**Re: Starbucks**  
**1440 Coors Blvd. NW**  
**30-Day Temporary Certificate of Occupancy**  
**Transportation Development Final Inspection**  
Architect's Stamp dated 9-14-22 (J11D017)  
Certification dated 6-16-23

Based upon the information provided in your submittal received 06-22-23, Transportation Development has no objection to a 30-day Temporary Certificate of Occupancy based. This letter serves as a "green tag" from Transportation Development for a 30-day Temporary Certificate of Occupancy to be issued by the Building and Safety Division.

Prior to the issuance of a permanent Certificate of Occupancy, the following items must be addressed:

SHEET TITLE  
ARCHITECTURAL  
SITE PLAN FOR  
TRAFFIC CIRCULATION  
LAYOUT

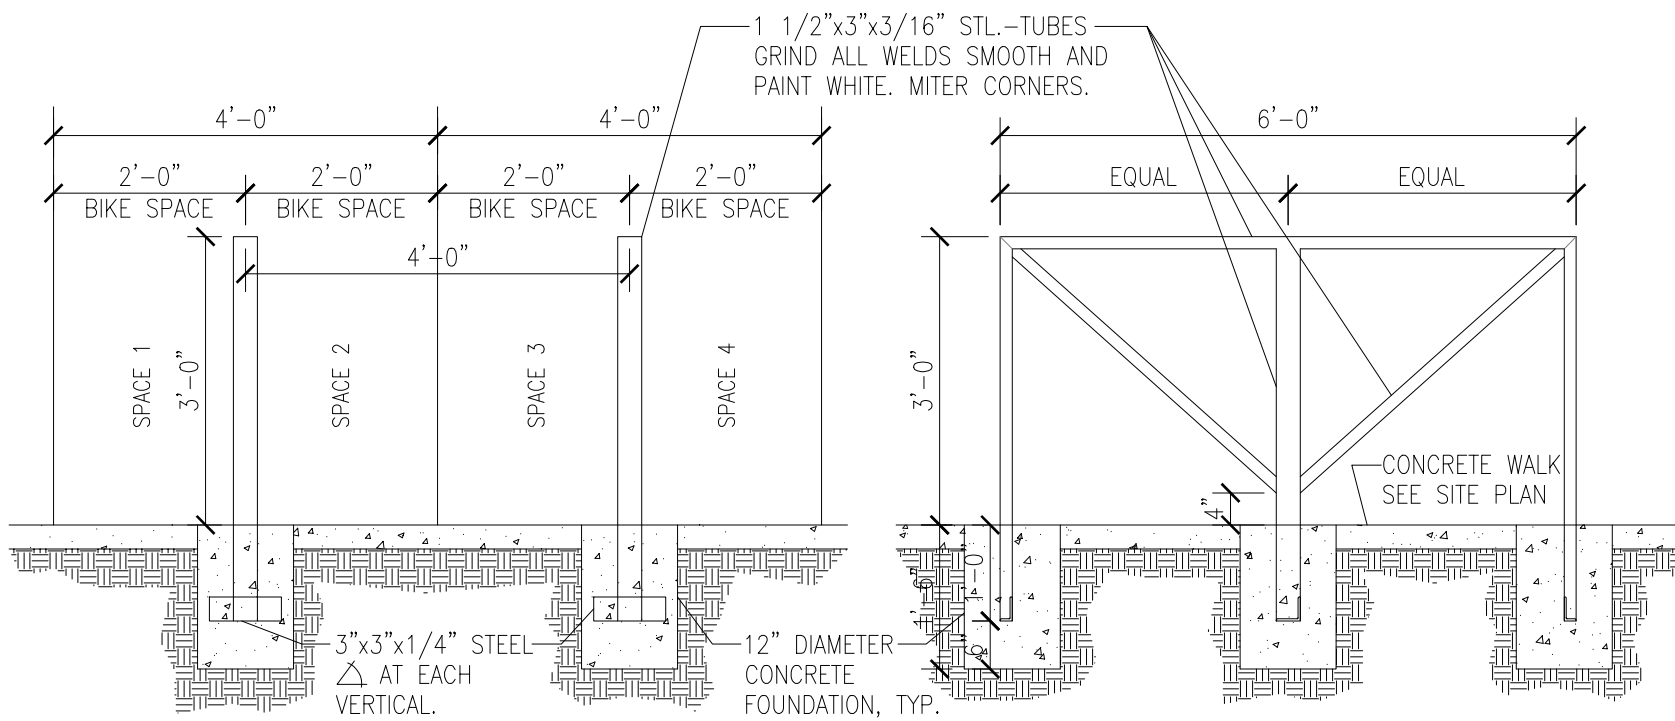
- There was a large shipping container blocking the access way for the ADA parking so I was unable to verify the NO PARKING at the rear of the access way.
- Per the approved plan, the "ONE WAY ONLY" pavement marking at the entrance to the drive-thru and the "DO NOT ENTER" pavement marking at the drive-thru exit were not in place.

Once these corrections are complete, email pictures to [earmijo@cabq.gov](mailto:earmijo@cabq.gov) for release of Final CO.
